ADDENDUM NO. 1

Date of Addendum: March 18, 2016

PROJECT NAME: Neighborhood Street Reconstruction Project No. 467

PROJECT NO: WBS No. N-000400-0001-4

WBS NUMBER	
N-000400-0001-4	
DRAWING SCALE	
VERT. 1"=2' HORIZ. 1"=20'	
CITY OF HOUSTON PM	
BEN BANSAL, P.E.	
SHEET No. 40 OF 226

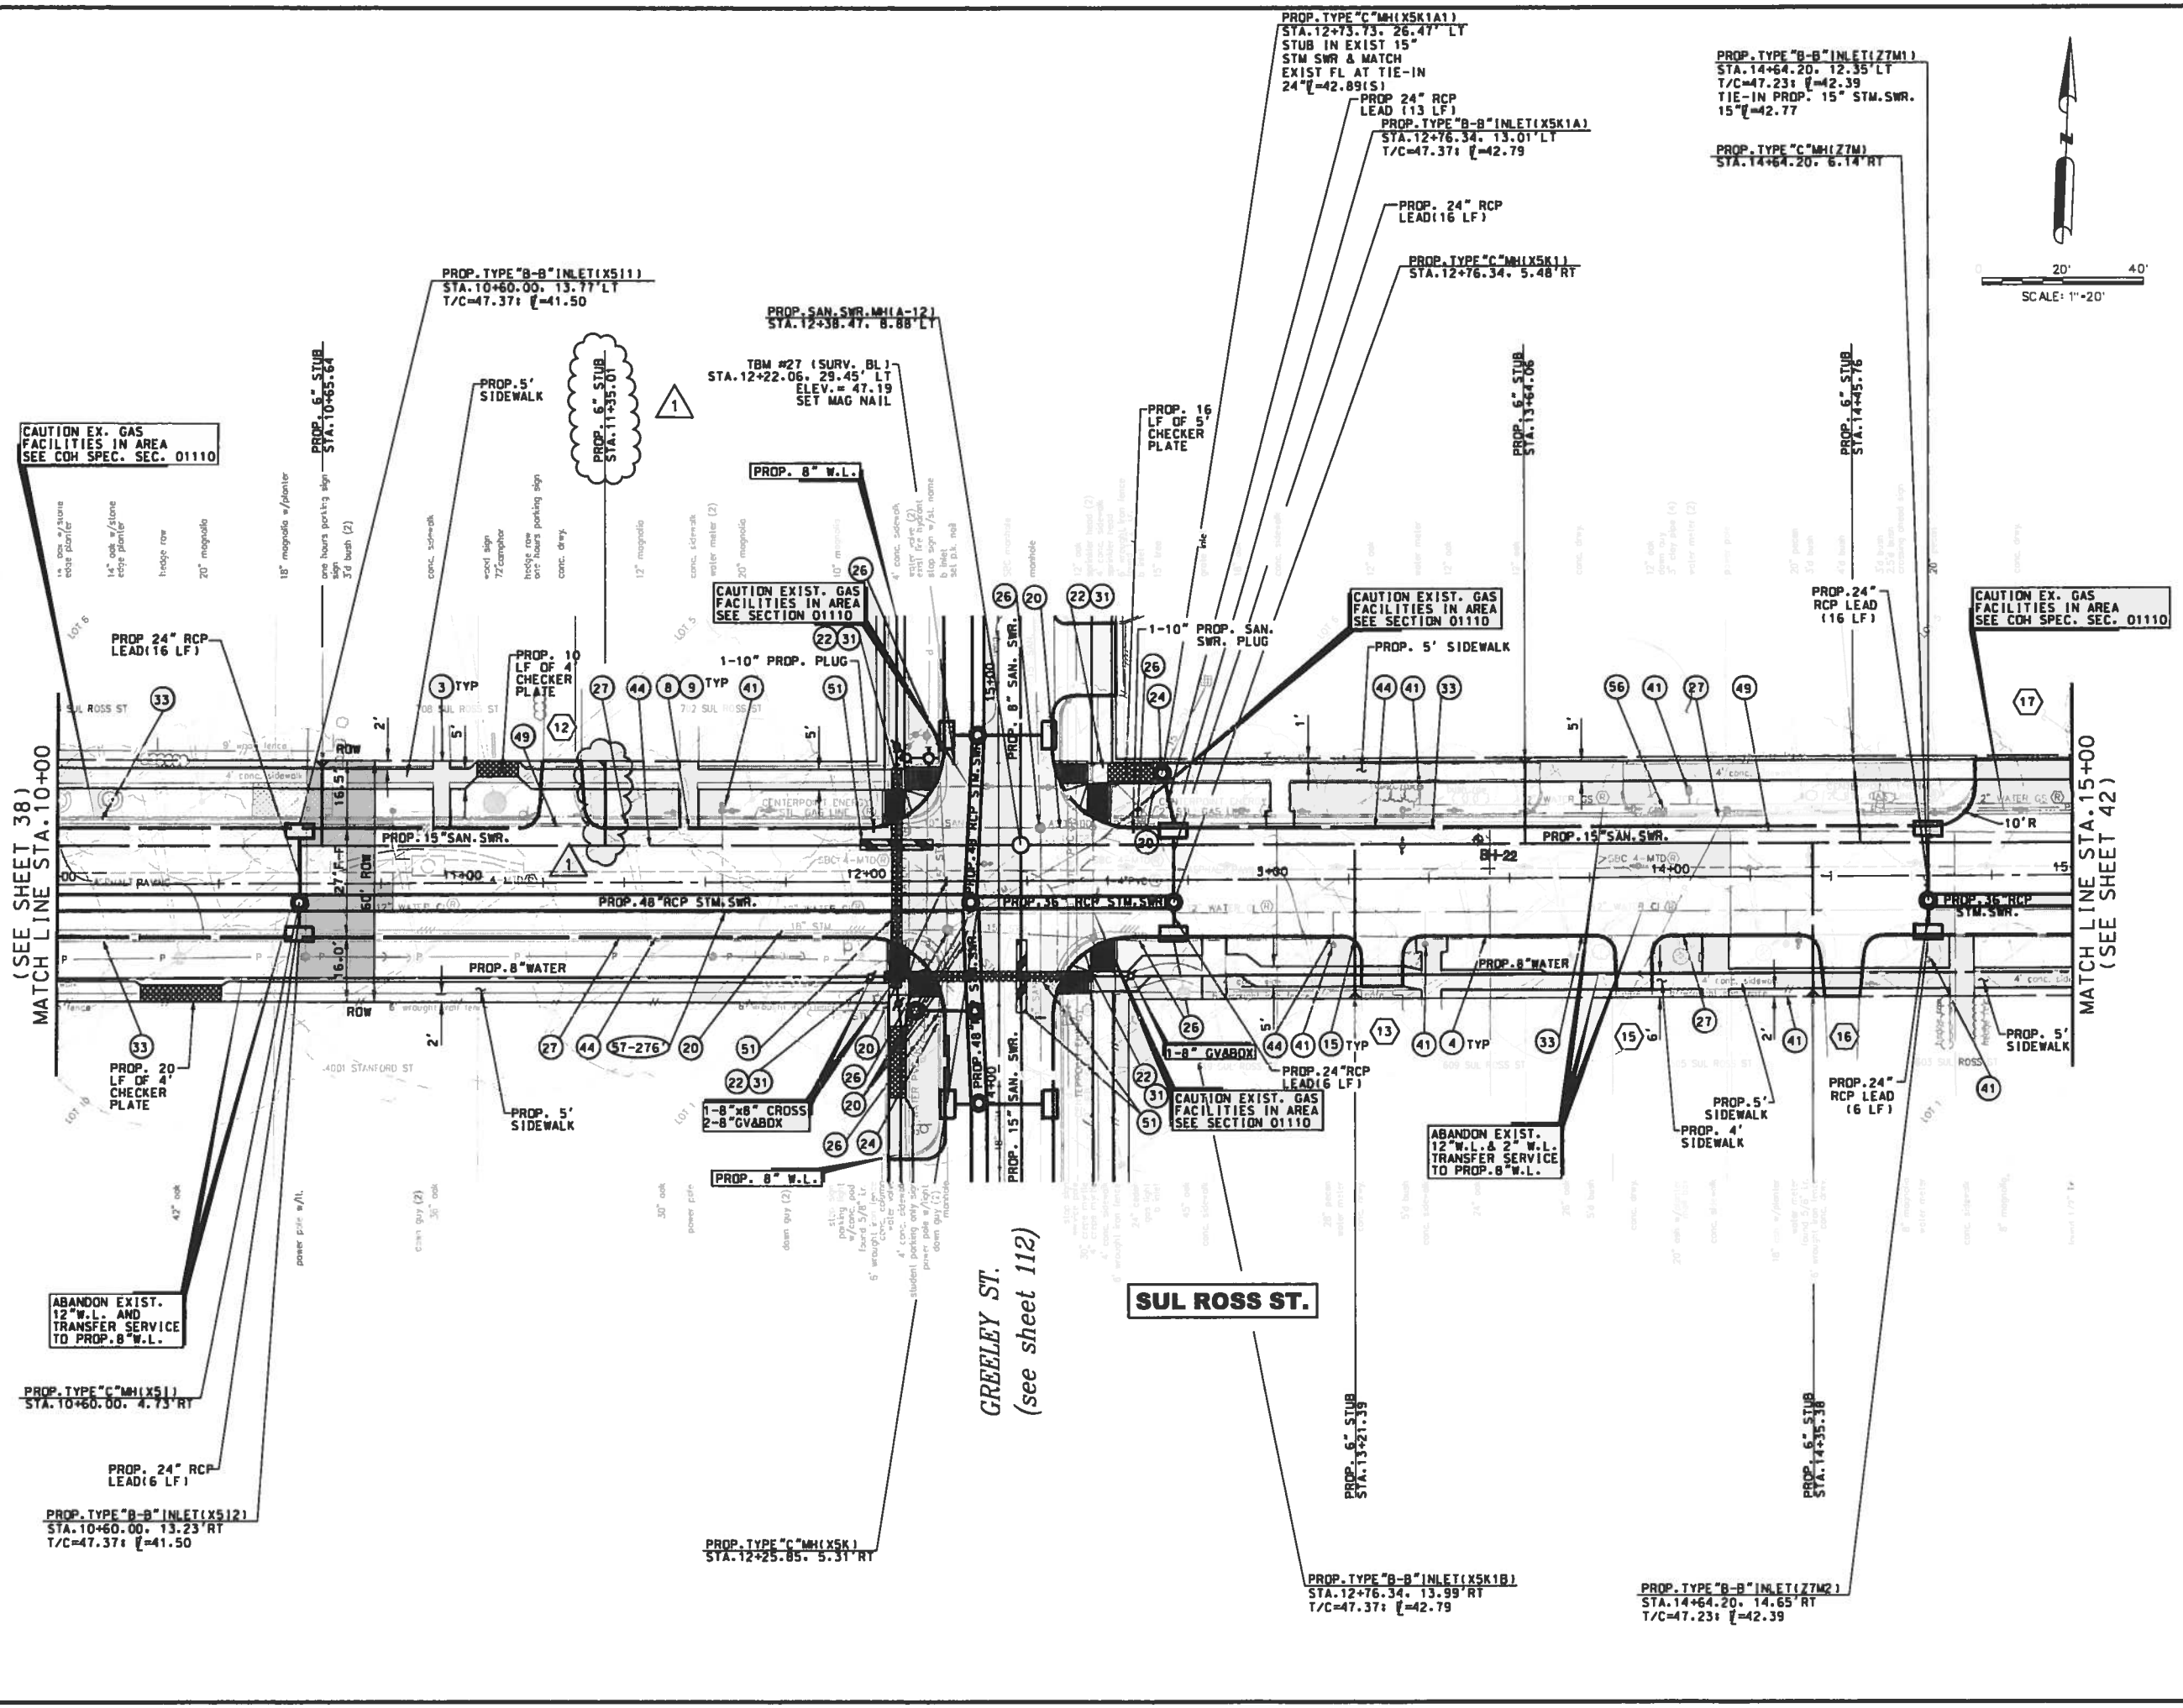
No.	DATE	REVISIONS	APP.
1	3/11	ADDENDUM #1 SERVICE STUBS REVISED	M.A.M

WBS NUMBER	N-000400-0001-4
DRAWING SCALE	VERT. 1"=2' HORIZ. 1"=20'
CITY OF HOUSTON PM	BEN BANSAL, P.E.
SHEET No. 41 OF 226

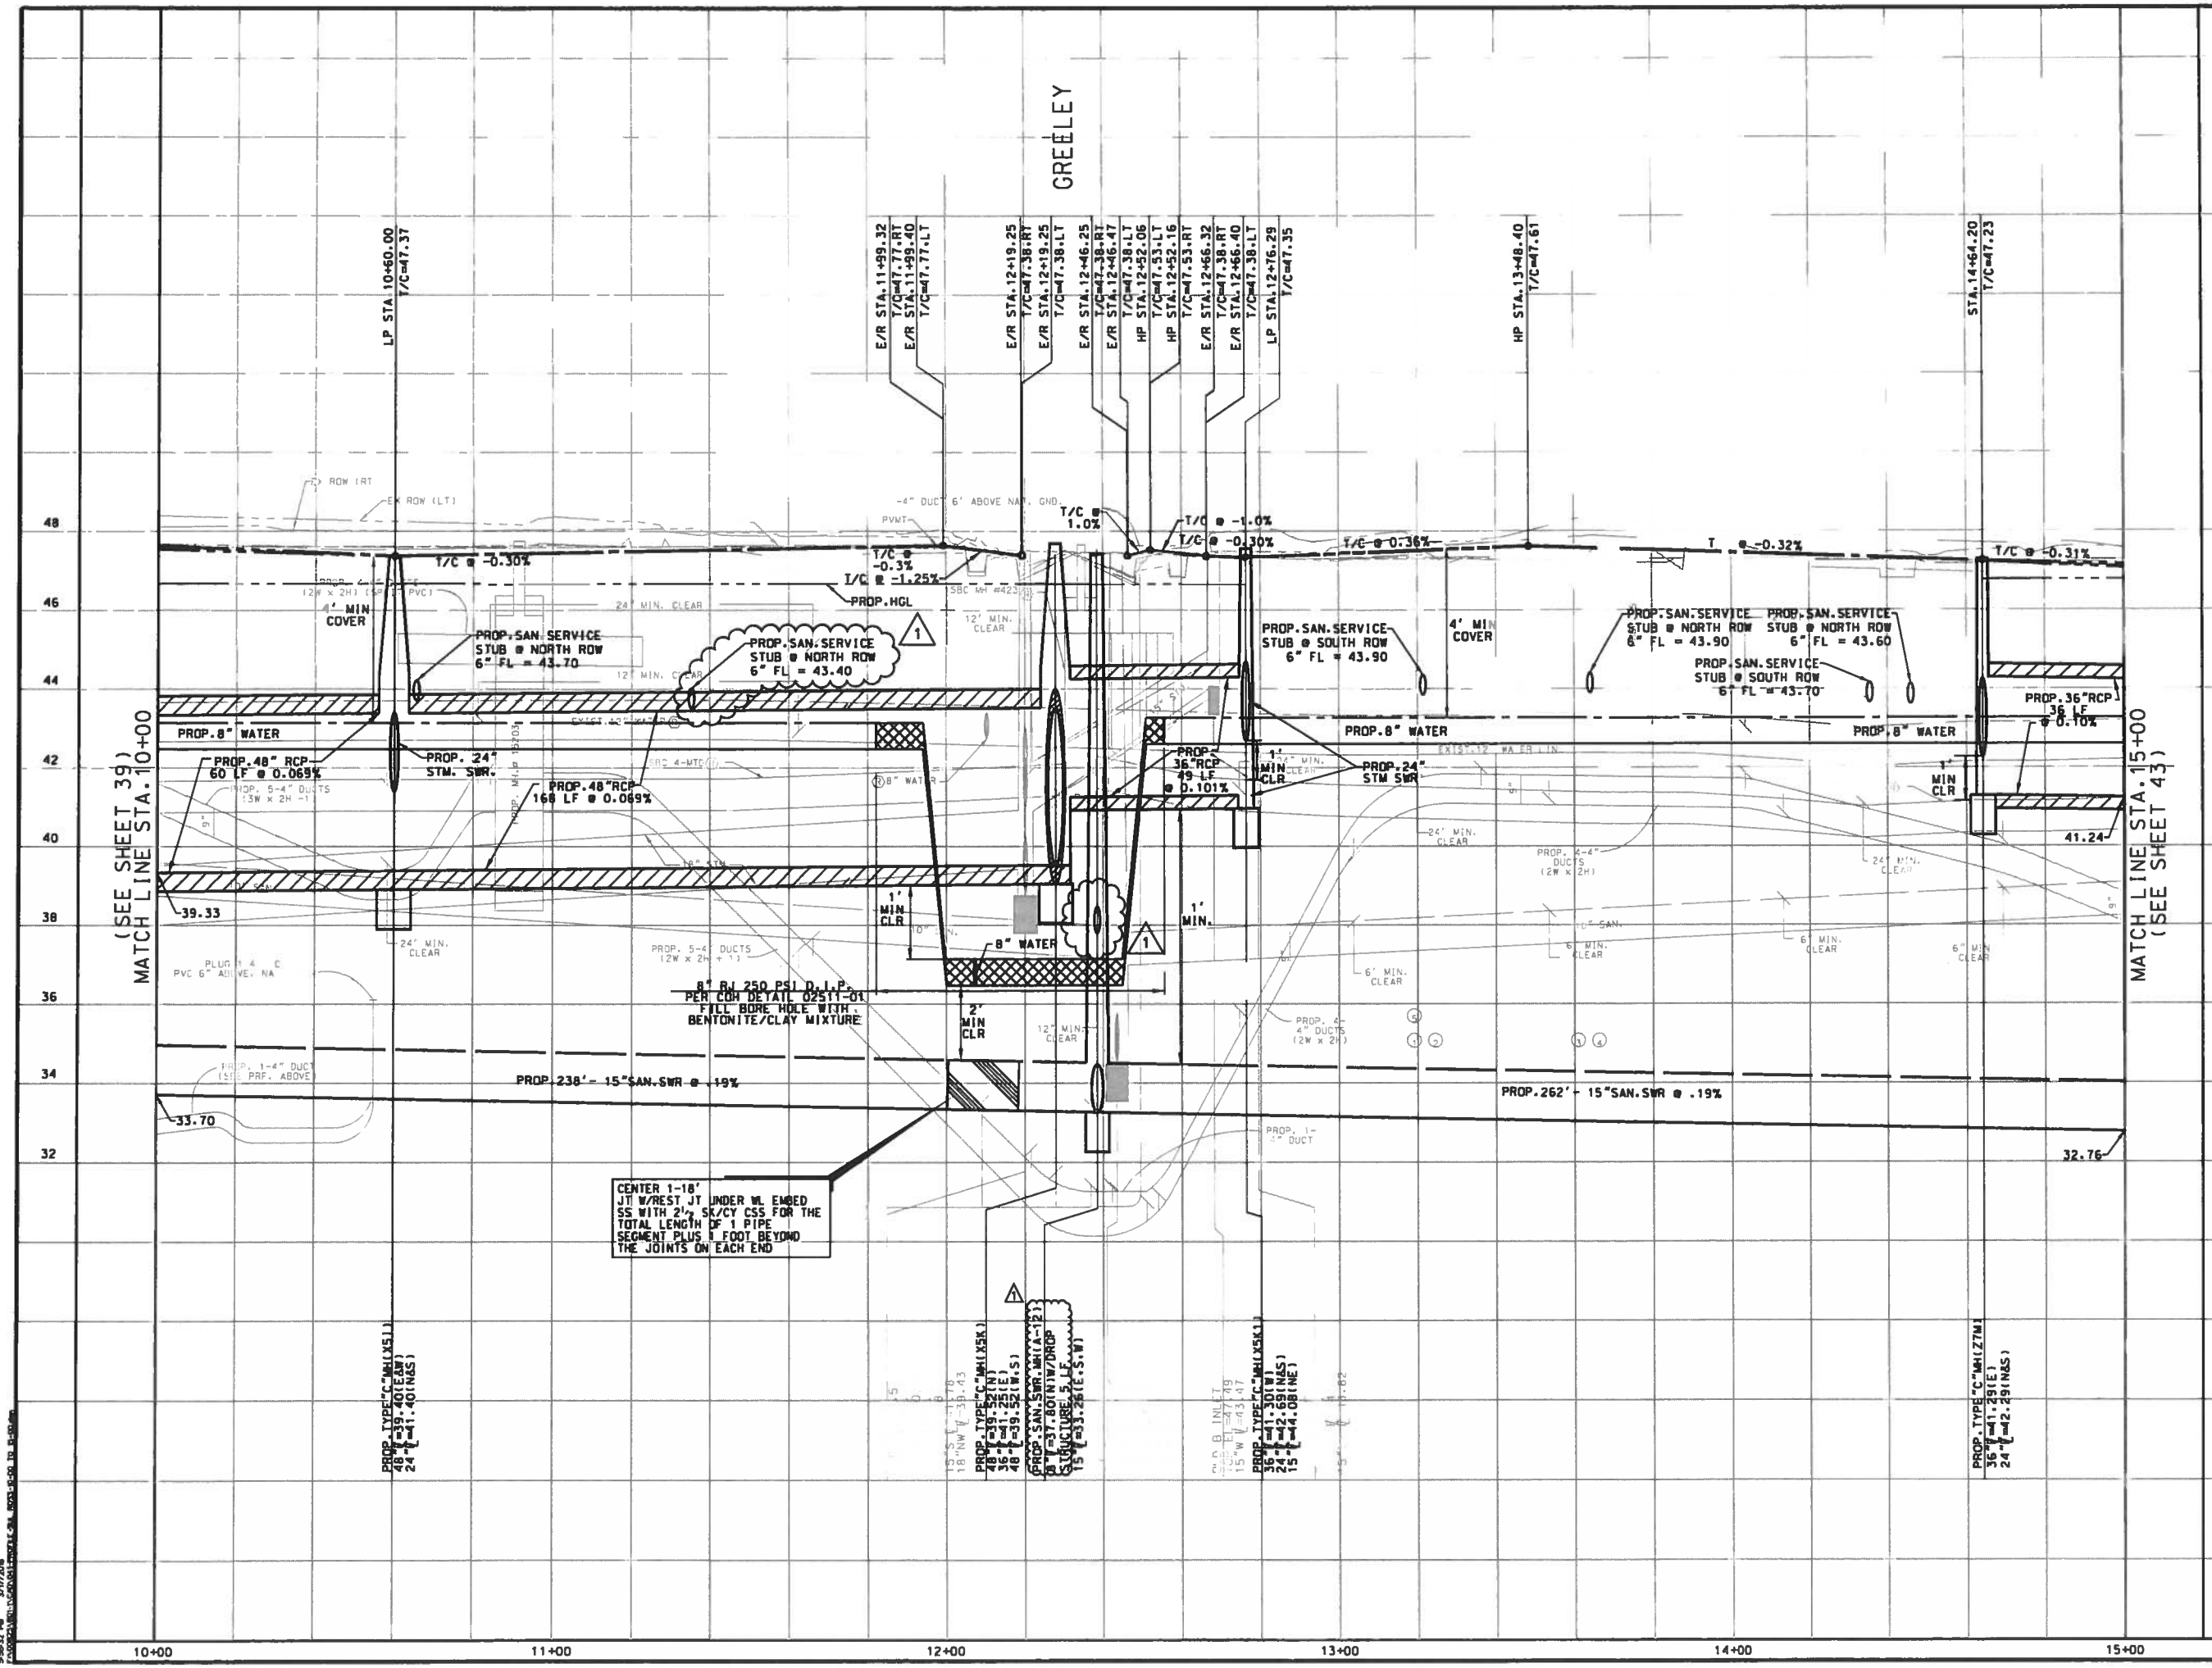
No.	DATE	REVISIONS	APP.
1	3/11	ADDENDUM #1 SAN.SWR. & SERVICE STUB REVISED	M.A.M.

WBS NUMBER	
N-000400-0001-4	
DRAWING SCALE	
VERT. 1"=2' HORIZ. 1"=20'	
CITY OF HOUSTON PM	
BEN BANSAL, P.E.	
SHEET No. 42 OF 226

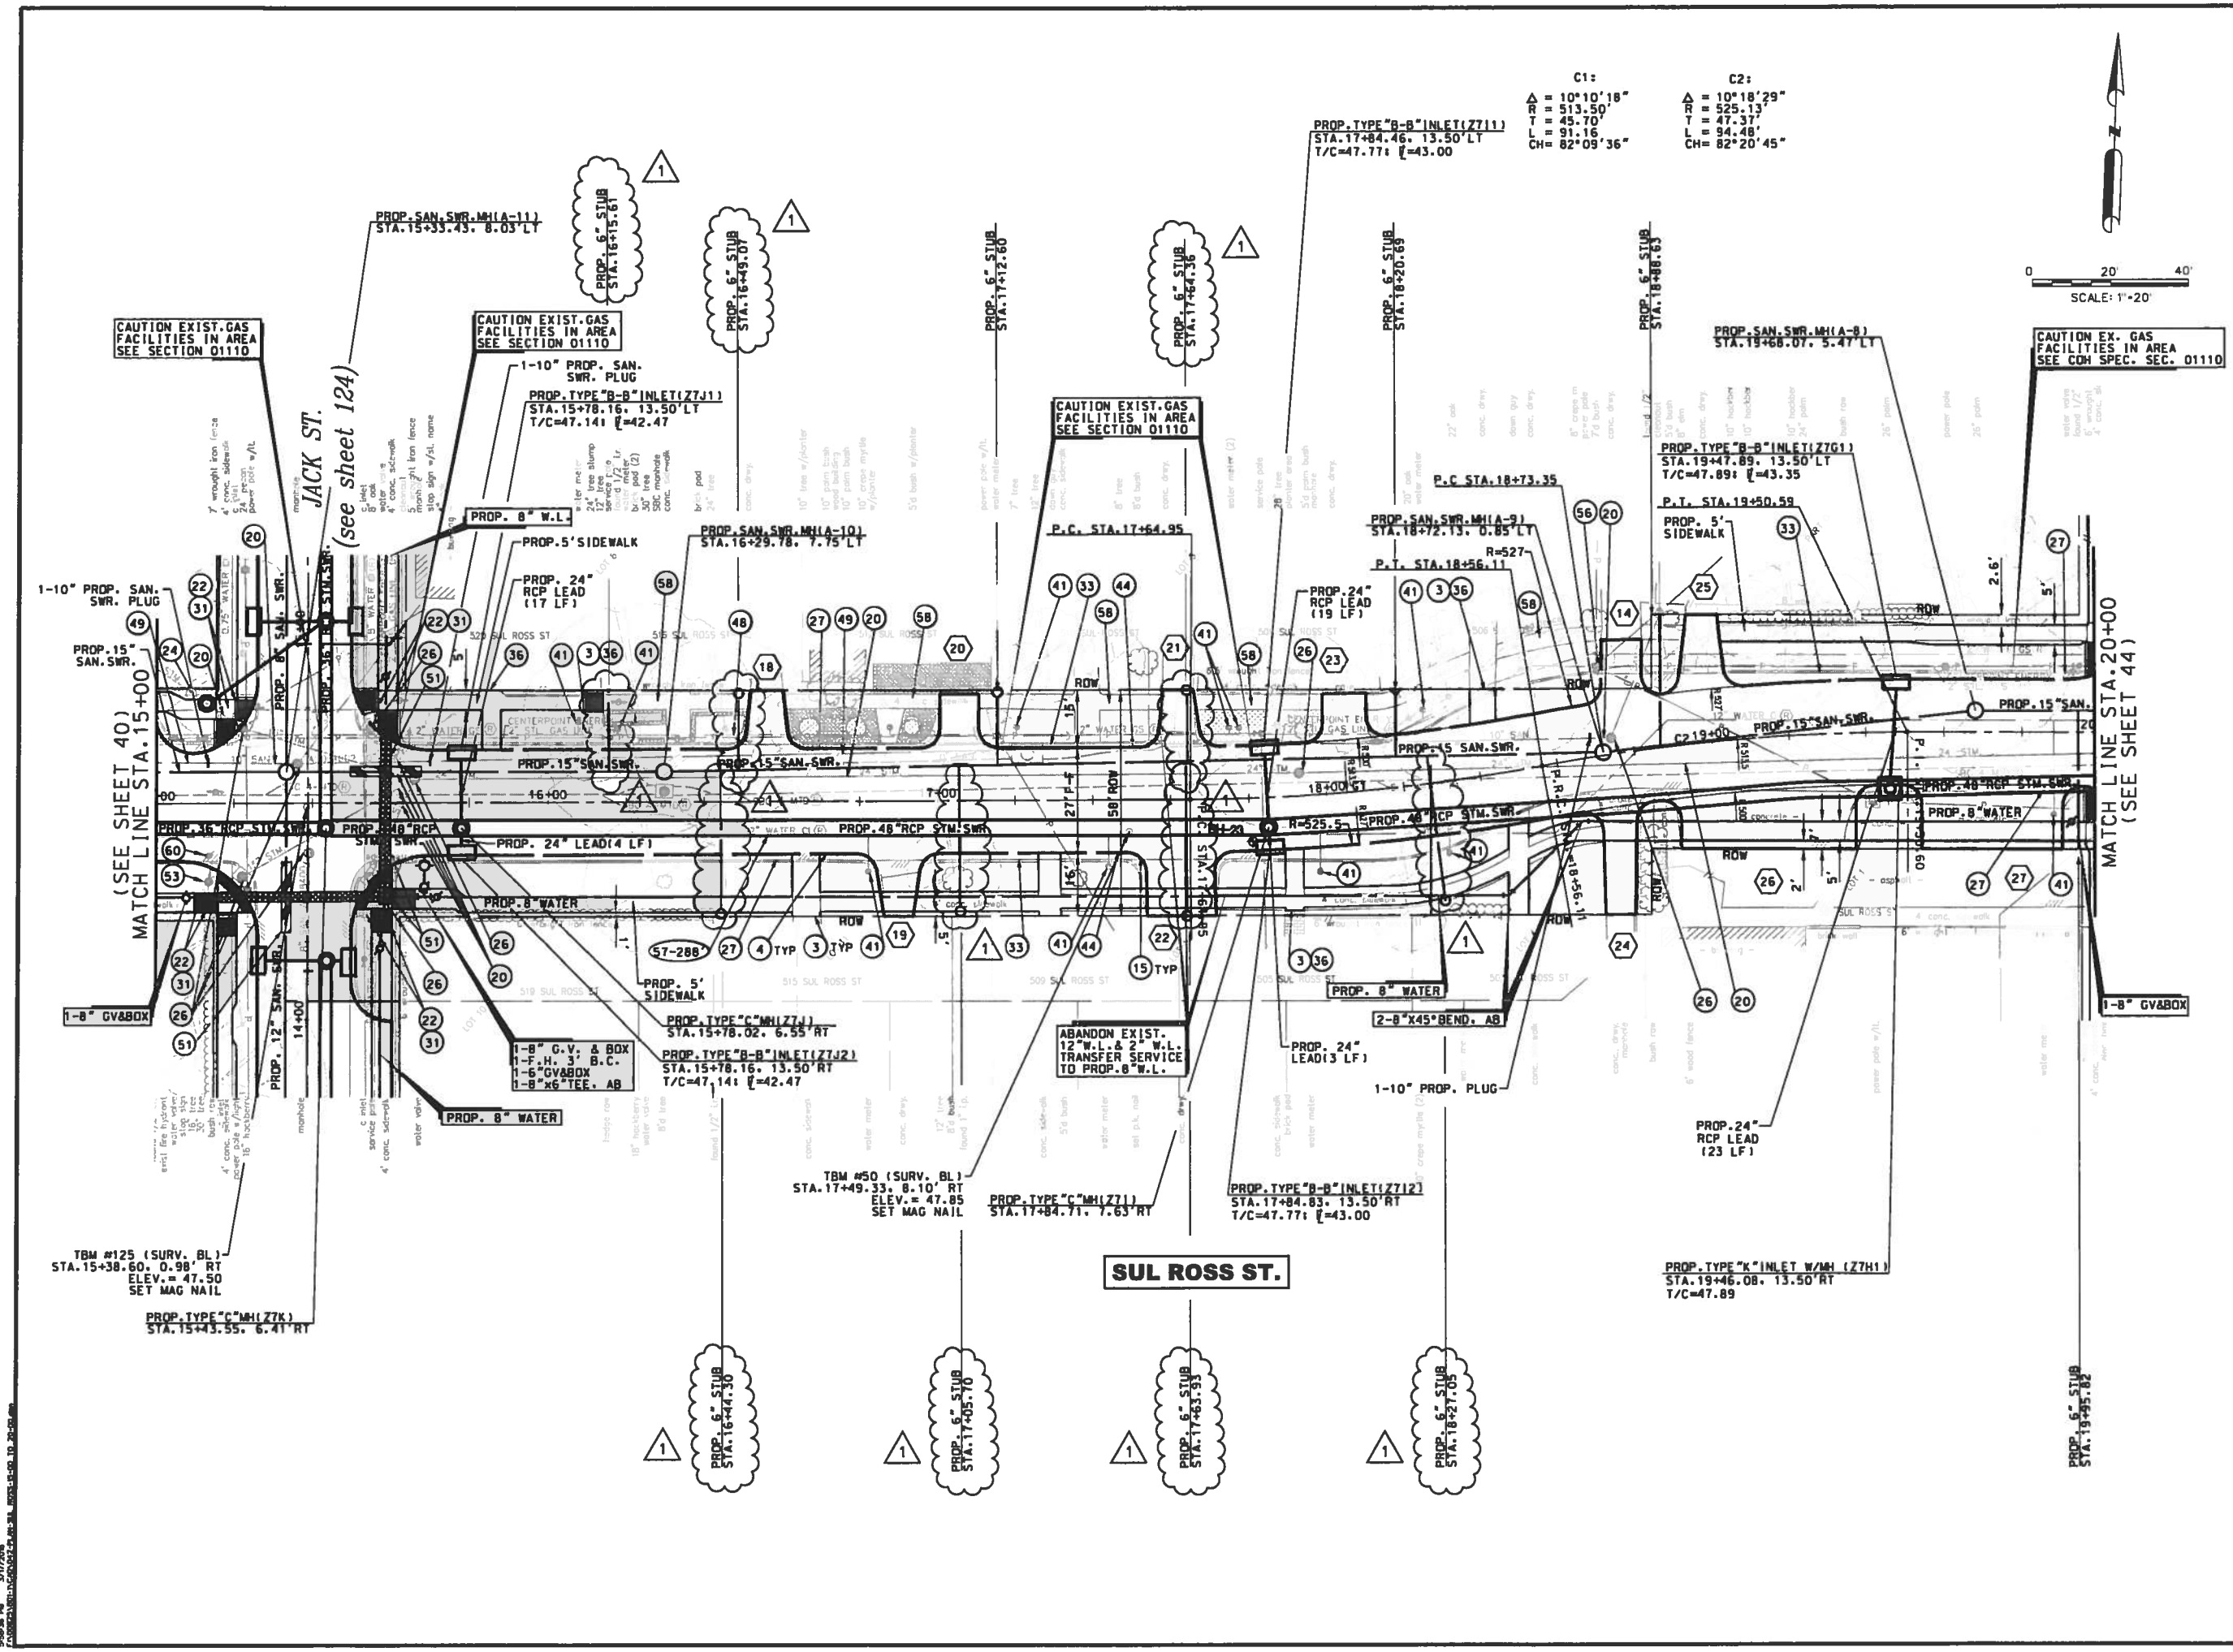
No.	DATE	REVISIONS	APP.
1	3/11	ADDENDUM #1 SERVICE STUBS REVISED	M.A.M.
